**ADA TOWNSHIP PLANNING COMMISSION  
THURSDAY, AUGUST 20, 2020 MEETING, 7:00 PM**

**TO:** Ada Township Planning Commission  
**FROM:** Jim Ferro, Planning Director  
**RE:** PVM District Development Plan, Renovation and addition to existing office building and parking, 555 Ada Drive SE., Parcel No. 41-15-34-101-045, Erhardt Construction, on behalf of Orchard Hills Properties, LLC

**TO:** Ada Township Planning Commission  
**FROM:** Brent M. Bajdek, Planner/Zoning Administrator  
**RE:** August 20, 2020 Agenda Item – 3046 & 3050 Pettis Ave. NE  
(*New Business – Item #2*)

**555 Ada Drive SE**  
**S.E.S.C. & Grading Plan**  
 PART OF THE NORTHWEST 1/4 OF SECTION 34, T7N, R10W,  
 ADA TOWNSHIP, KENT COUNTY, MICHIGAN

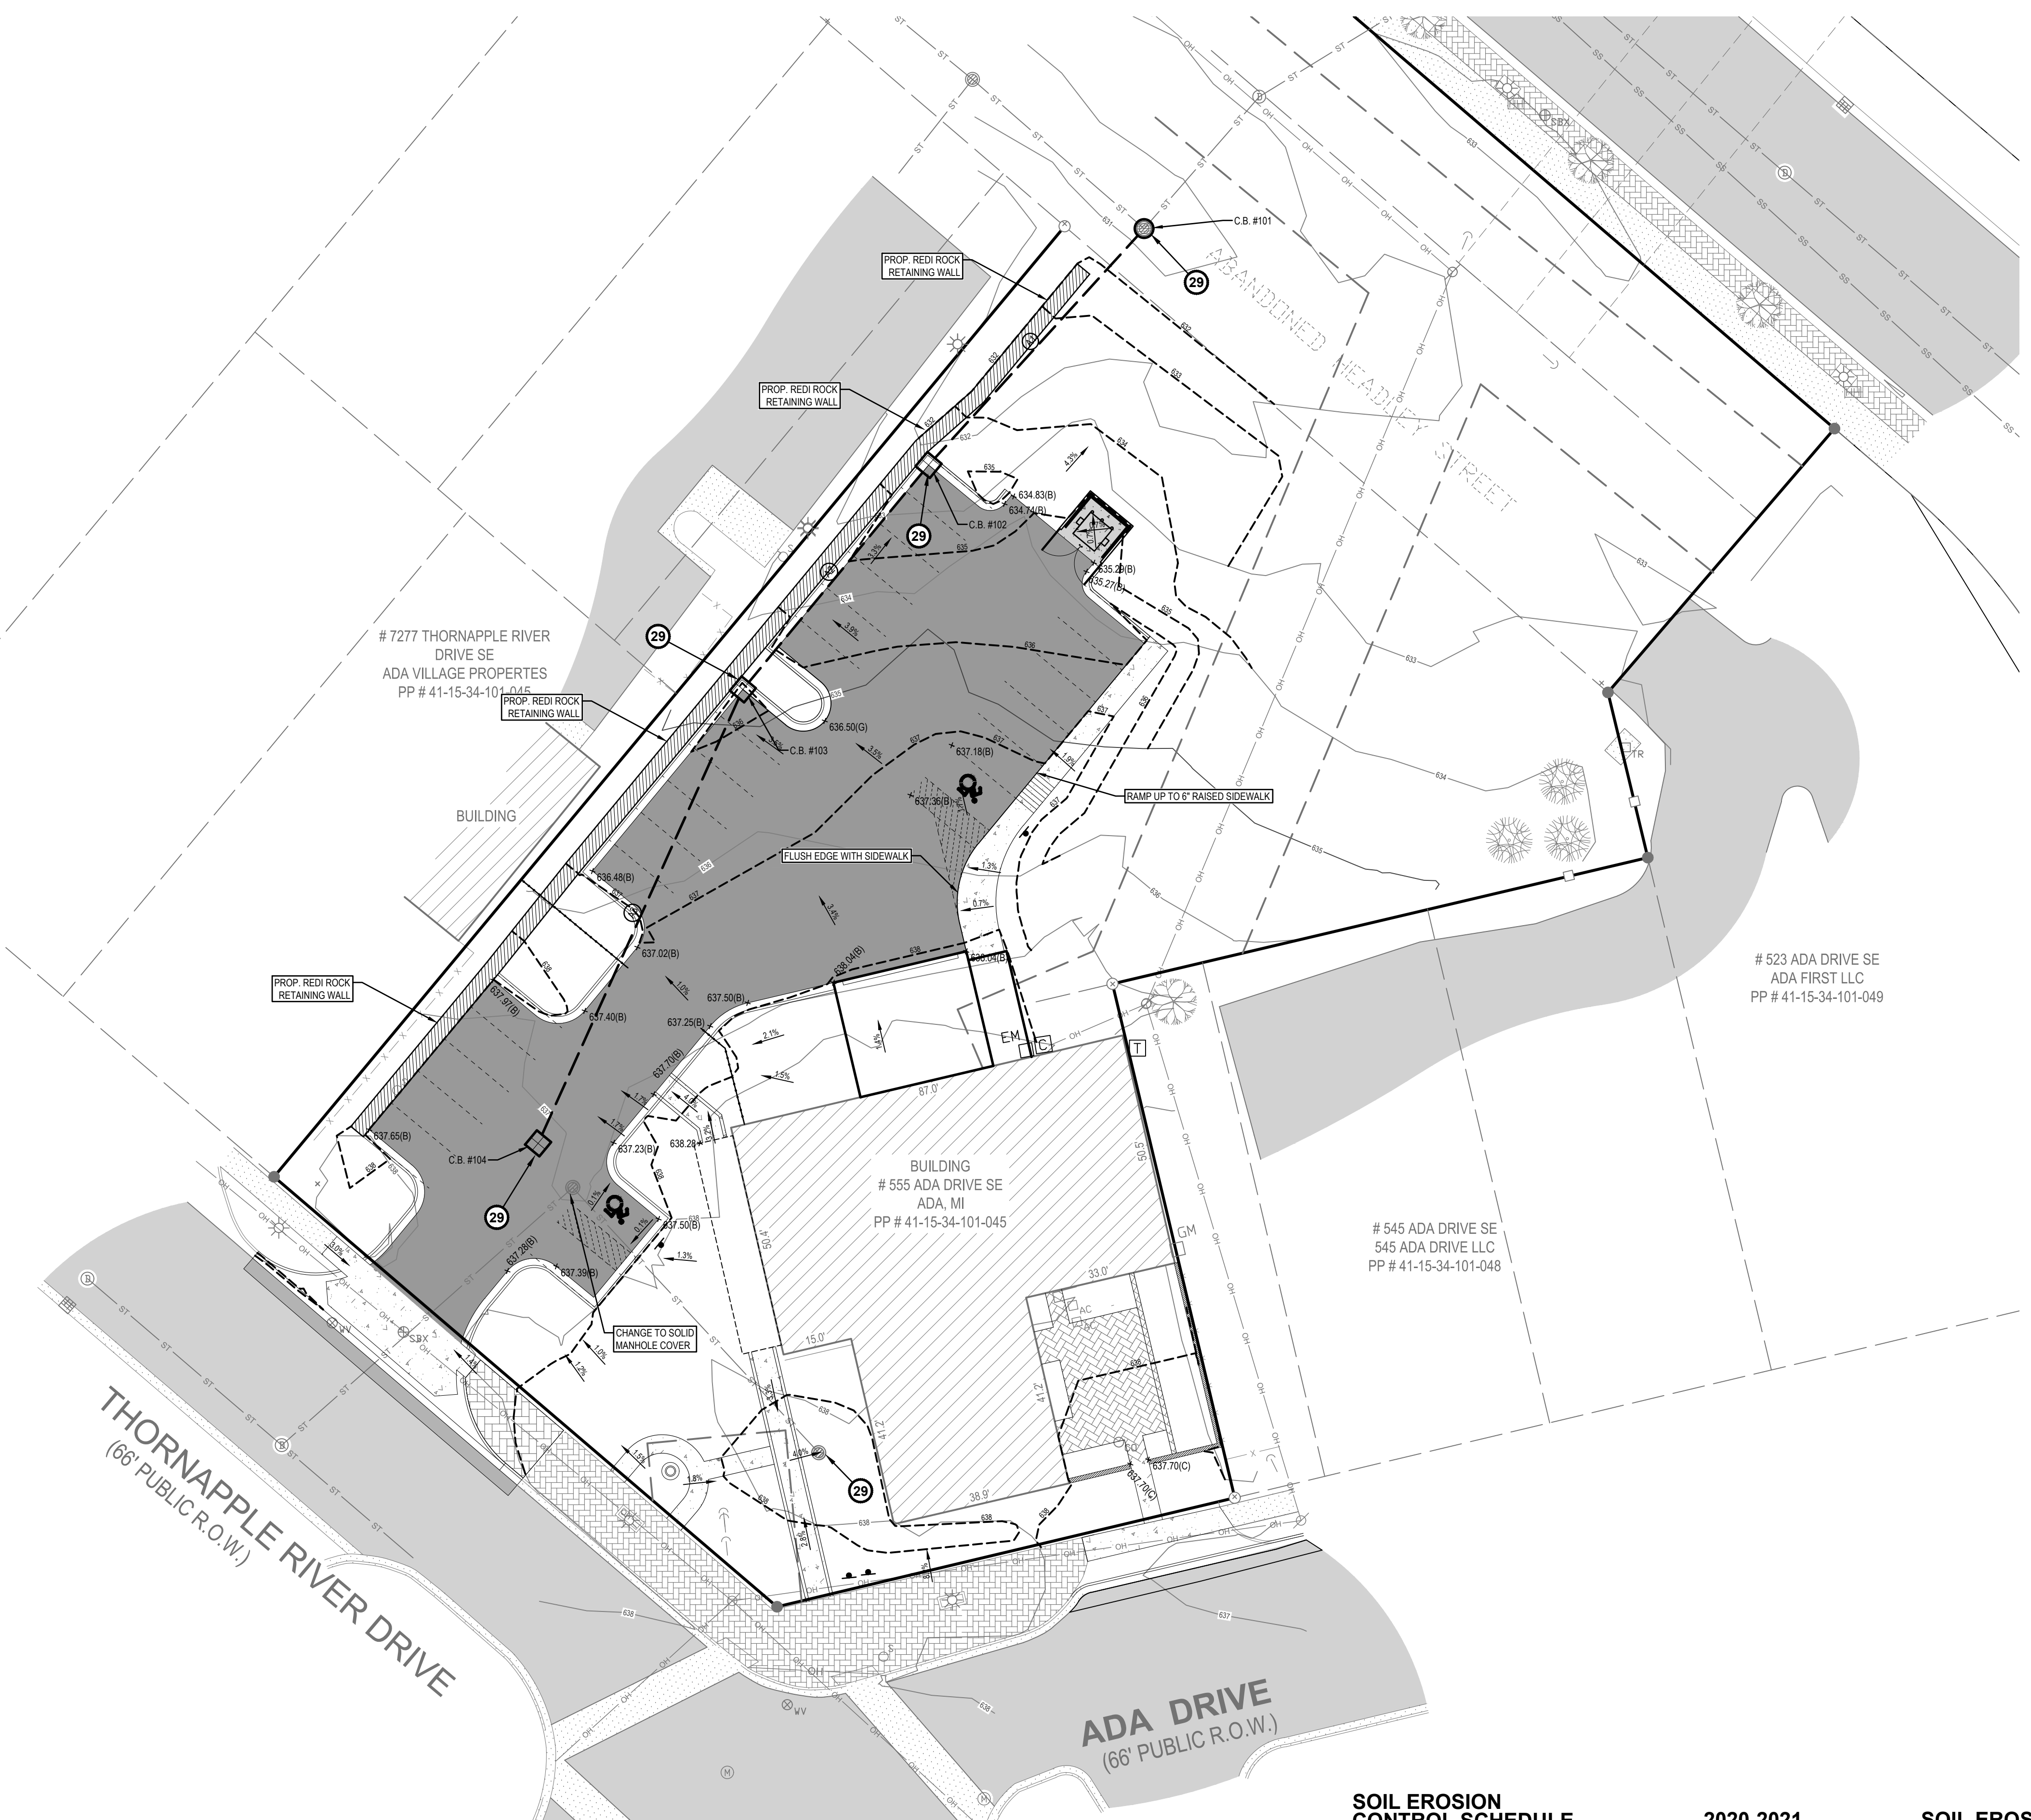
The grading and drainage plan adds a short (1 foot high) retaining wall along the west edge of the parking area. This will correct the existing condition in which pavement runoff flows onto the adjoining property.

Sheet Title:  
**LANDSCAPE PLAN**

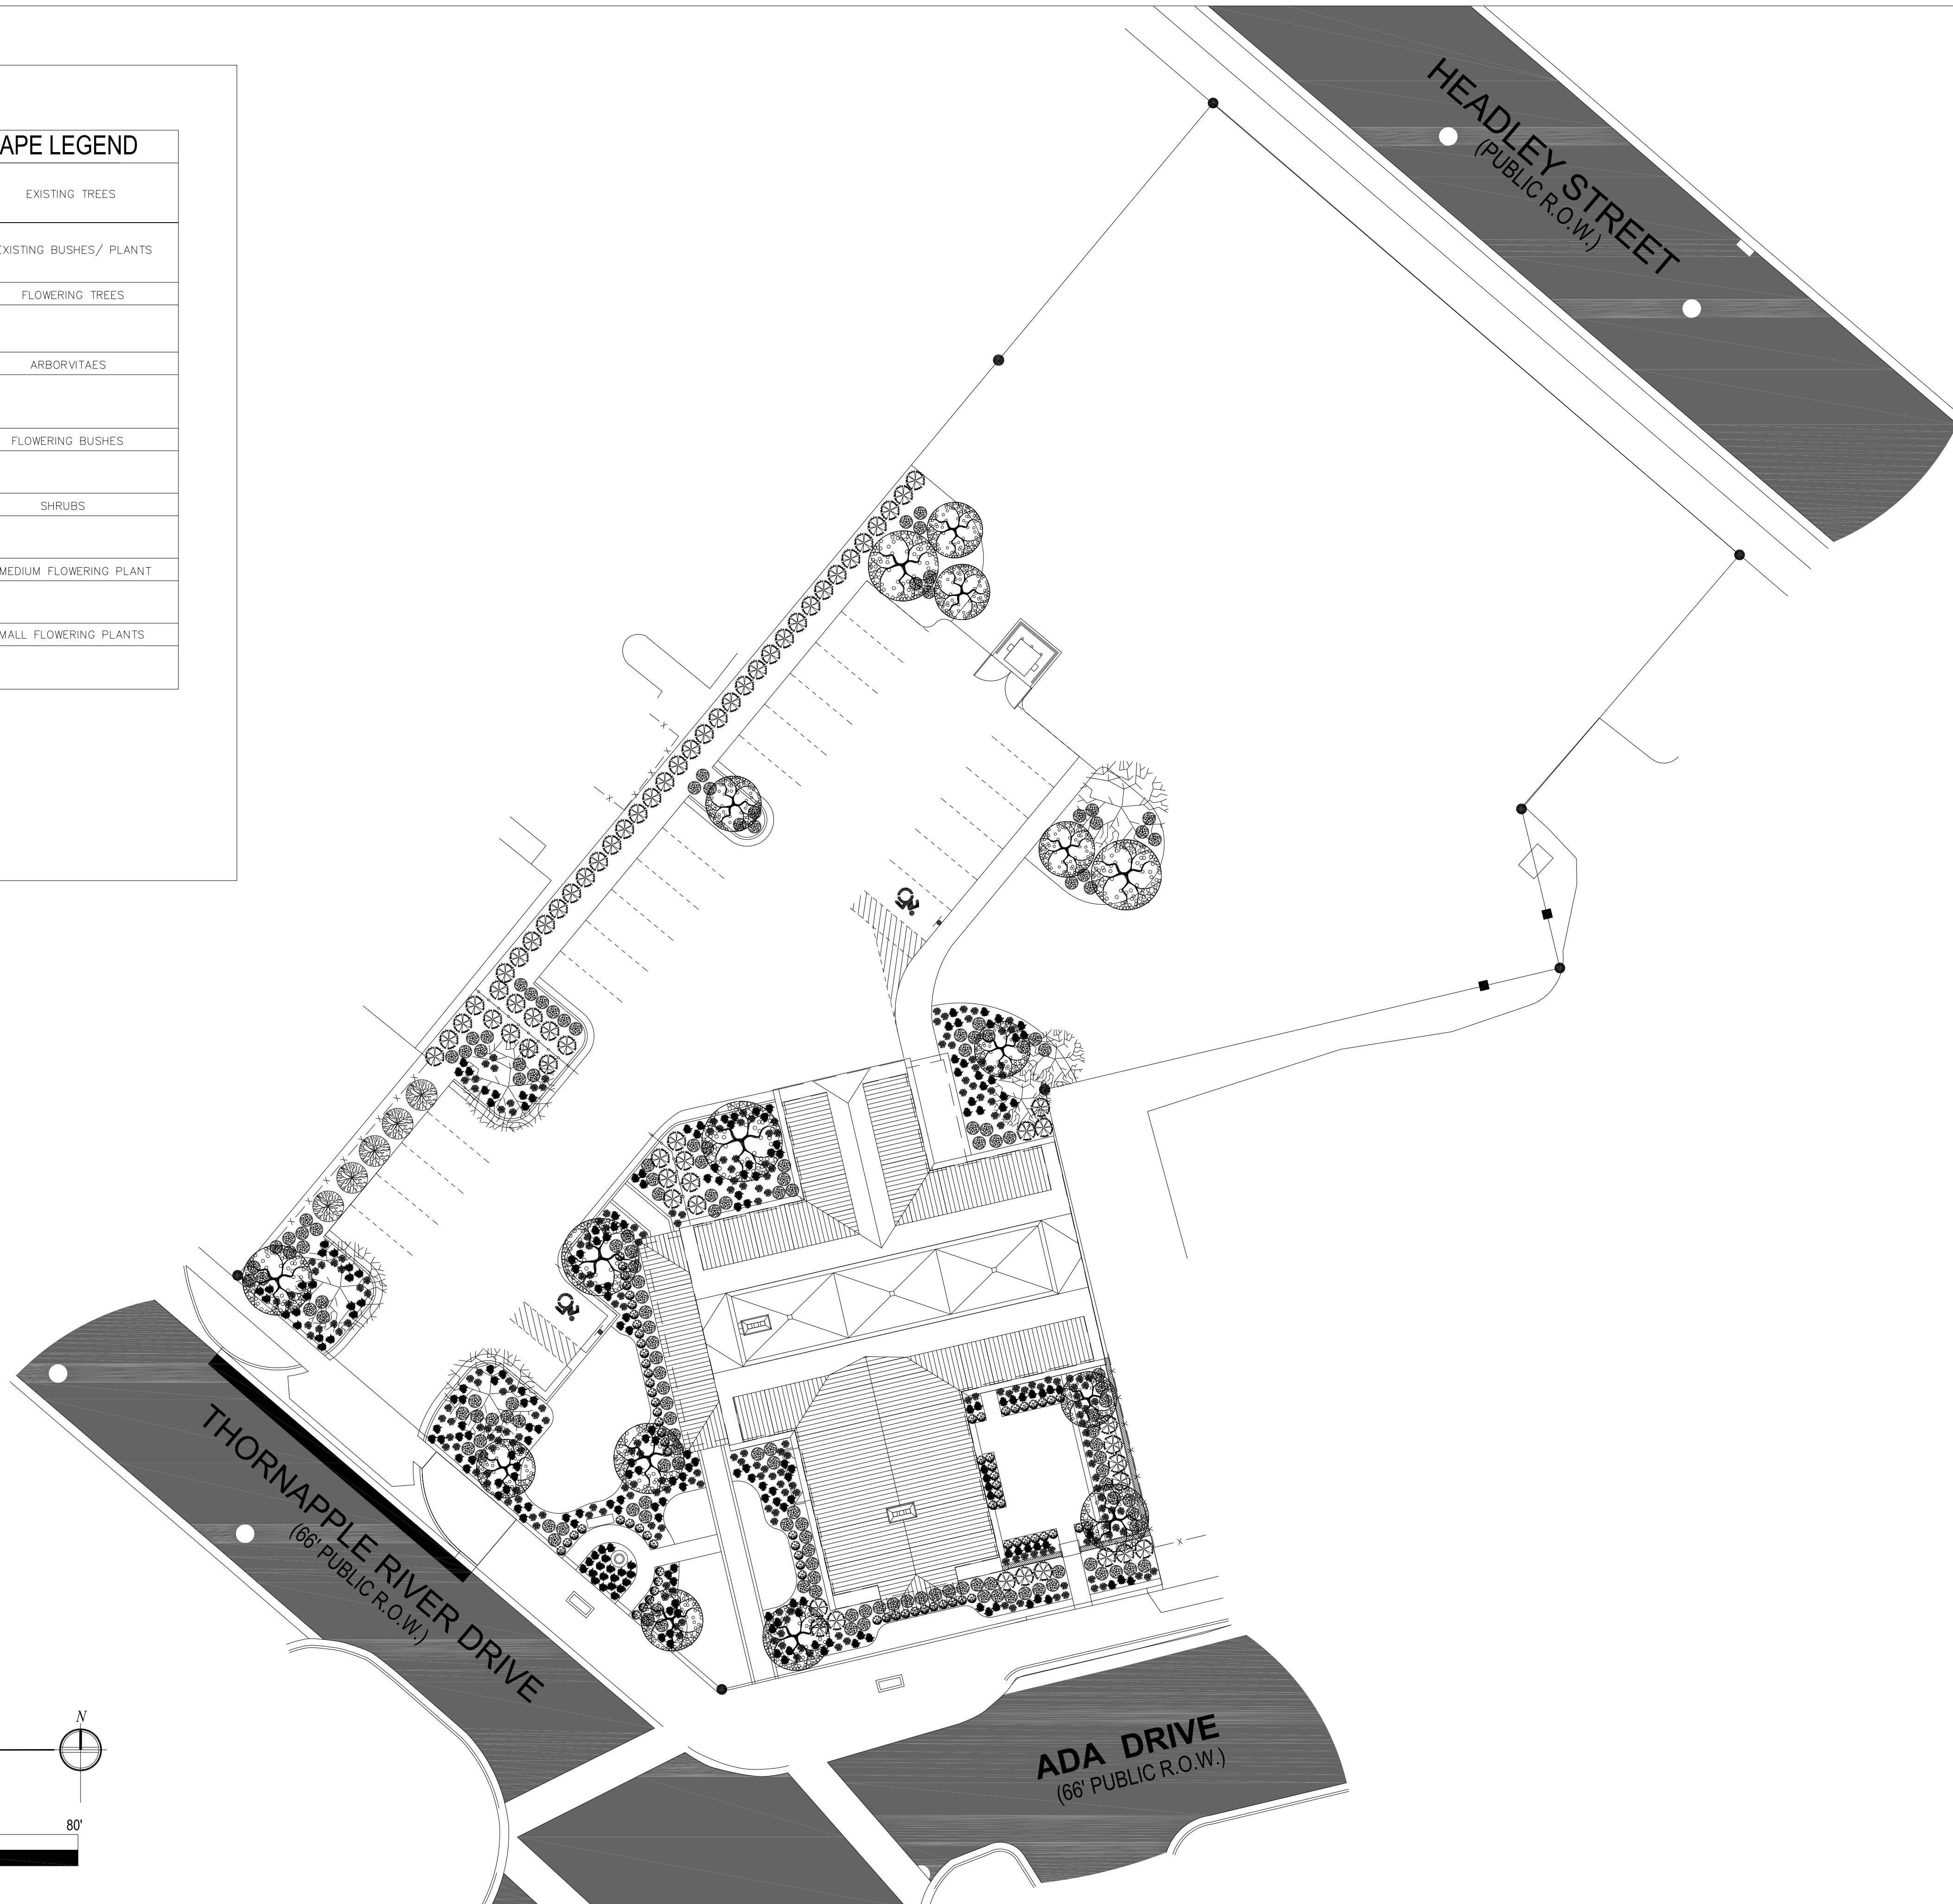
A conceptual landscape plan has been submitted, which shows substantial quantities of ornamental trees, shrubs and flowering plants installed around most of the building perimeter and at property line perimeters.

A more detailed plan providing quantities, sizes and species of plantings should be submitted for review and approval by Township staff prior to initiation of landscape improvements.

4. The demolition plan shall be modified to identify trees to be removed.
5. The landscape plan shall be revised to identify quantities, sizes and species of plant materials, for review and approval by Township staff prior to initiation of landscape improvements.

Sheet Title:  
**ELEVATION  
WEST & SOUTH**

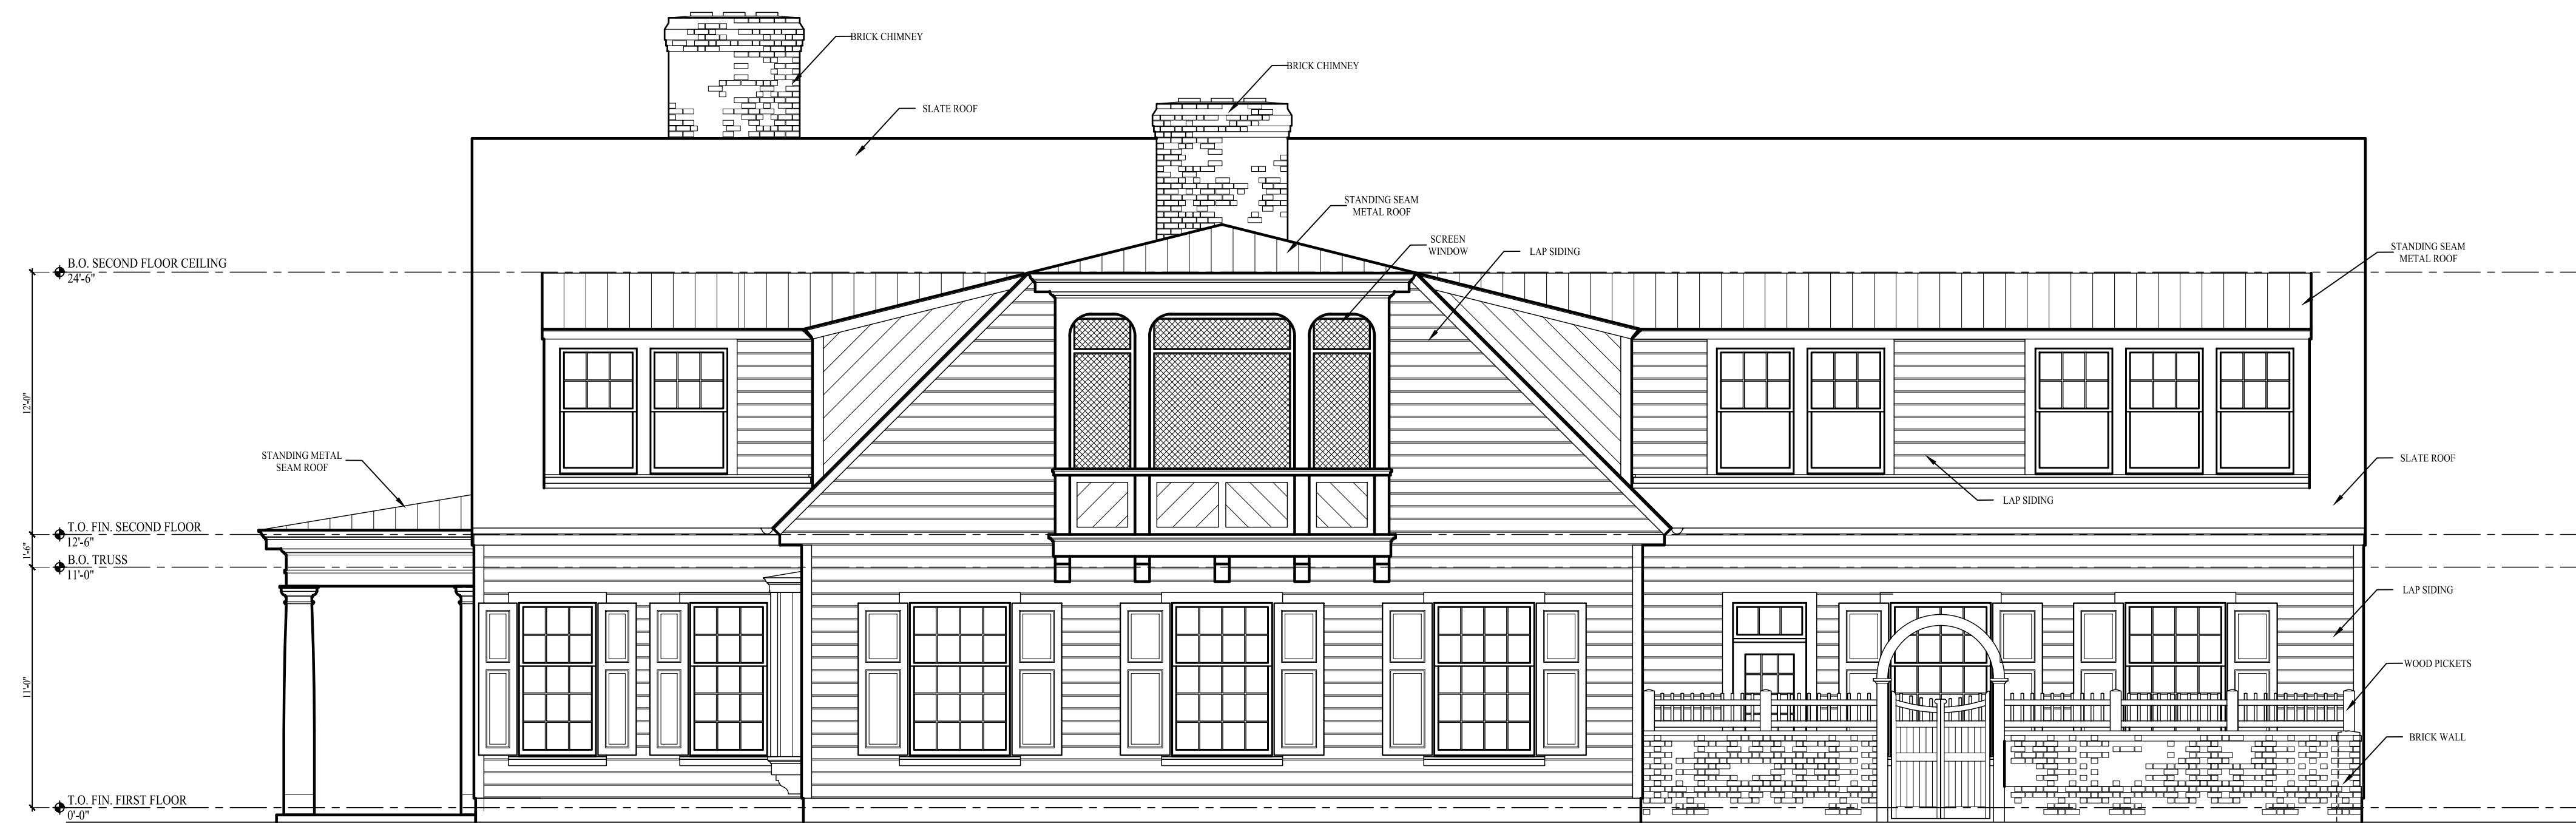
The addition of new dormers within the roof give the building more of a 2-story appearance and break up the mass of the roof, which dominates the existing building. Window styles, groupings and dimensions all conform with the PVM district standards.
